Design Hazard Review: DSRP Bench Unit

SLIPSTREAM PILOT TEST UNITS FOR DIRECT SULFUR RECOVERY PROCESS AND ADVANCED HOT GAS PROCESS

August 2000

PSDF FIELD TEST
 P&ID - LS02 DELIVERY SYSTEM
 DSRP & ANRP
 WASHINGTON, AL
 DOE-FETC
 DWG. NO. P100118

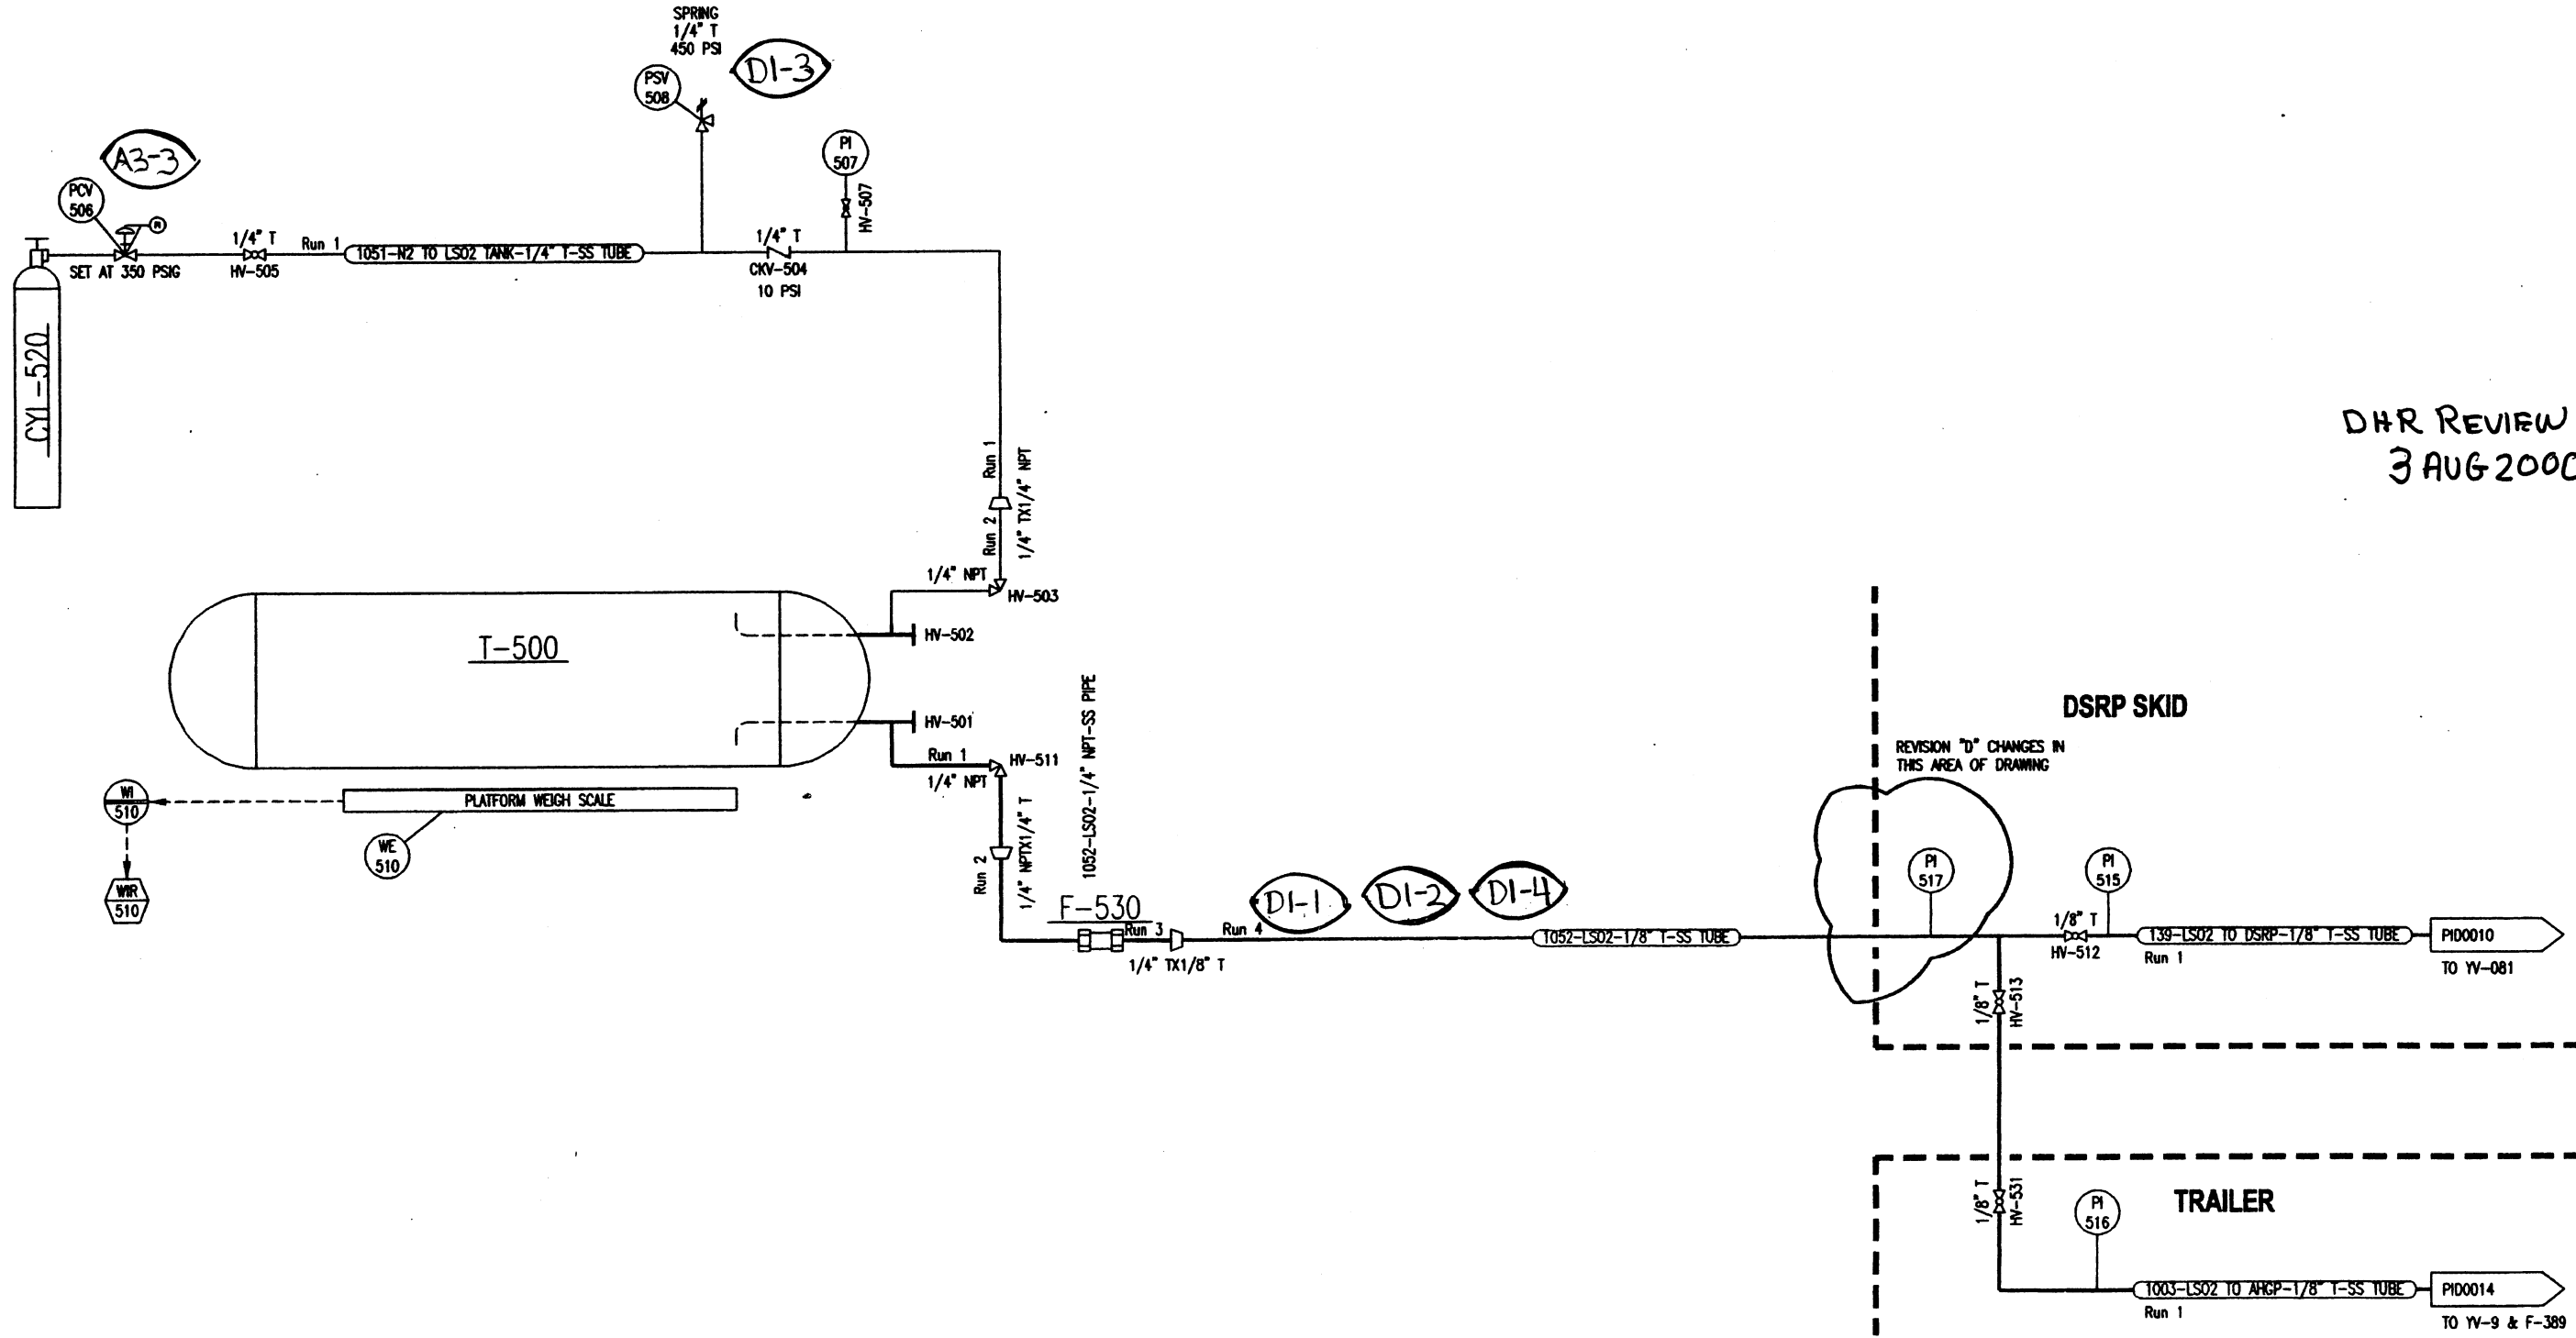
A3-3	PID-0018 T-500 PCV-506	Reverse flow of nitrogen to T-500 LSO ₂ cylinder.	Low nitrogen pad pressure on T-500.	O-Loss of SIMROG flow (refer to A3-2)	<ul style="list-style-type: none"> Operator procedure and monitoring. Rotameter float may close restricting backflow. Nitrogen pressure via PCV-612 available. 	Confirm procedure and data logging monitors T-500 tank pad pressure at acceptable frequency.	RTI	
A3-4	PID-0010 HX-090	High temperature from loss of nitrogen flow.	HTR-091 heater fails in shorted condition with TIC-094 selected to control outlet line temperature.	<ul style="list-style-type: none"> S-Potential for tube failure and release of toxic gas. Personnel exposure hazard. 	<ul style="list-style-type: none"> Operator monitoring and intervention. TSH-094. Dual temperature control mode configured. 	Review and confirm high temperature shutdown can be accommodated in either control modes to prevent equipment damage.	RTI

D1-3	PID-0018 T-500	High-pressure.	PCV-506 nitrogen pad regulator fails and PSV-506 undersized.	<ul style="list-style-type: none"> S-Potential for fuse plug blowout. High volume toxic gas release. 	<ul style="list-style-type: none"> PSV-508 (sizing unknown) T-500 fuse plug. 	<ul style="list-style-type: none"> Confirm sizing capacity of PSV-508. Get written guidance from air products for overpressure relief venting on T-500 padded cylinder. 	RTI	
D1-4	PID-0018	Low flow. High-pressure drop through tubing.	1/8" LSO ₂ supply tubing undersized for length of run.	<ul style="list-style-type: none"> O-SO₂ feed limited to DSRP. 	Unknown.	<ul style="list-style-type: none"> Review routing requirements (refer to D1-1) and check pressure drop at maximum feed rate. 	RTI
